MILITARY SPECIFICATION

PONTOONS, STEEL, SECTIONAL, P-SERIES:
DETAIL SPECIFICATION FOR

This Amendment forms a part of Military Specification MIL-P-19380/1, dated 28 March 1981, and is approved for use by all Departments and Agencies of the Department of Defense.

FIGURE 1 - MATING TEST CONFIGURATION

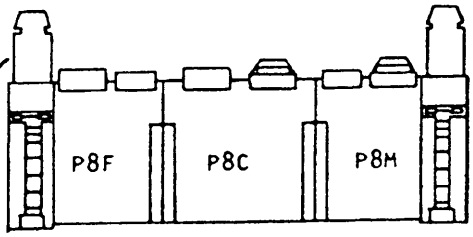
Insert: 4.4.3 Mating test. Unless otherwise specified (see 6.2), two sets of three pontoons each (P8M, P8C, P8F) shall be connected as shown in figure 1 with the flexor connectors installed in the receivers of one set for first article testing. Aline the two connected sets of P8's and join together. Failure of the flexor connectors and pipe and socket devices to match up with, and securely connect to, the appropriate receiver shall constitute failure of this test.

Insert attached figure, "FIGURE 1 - MATING TEST CONFIGURATION" as Page 6.
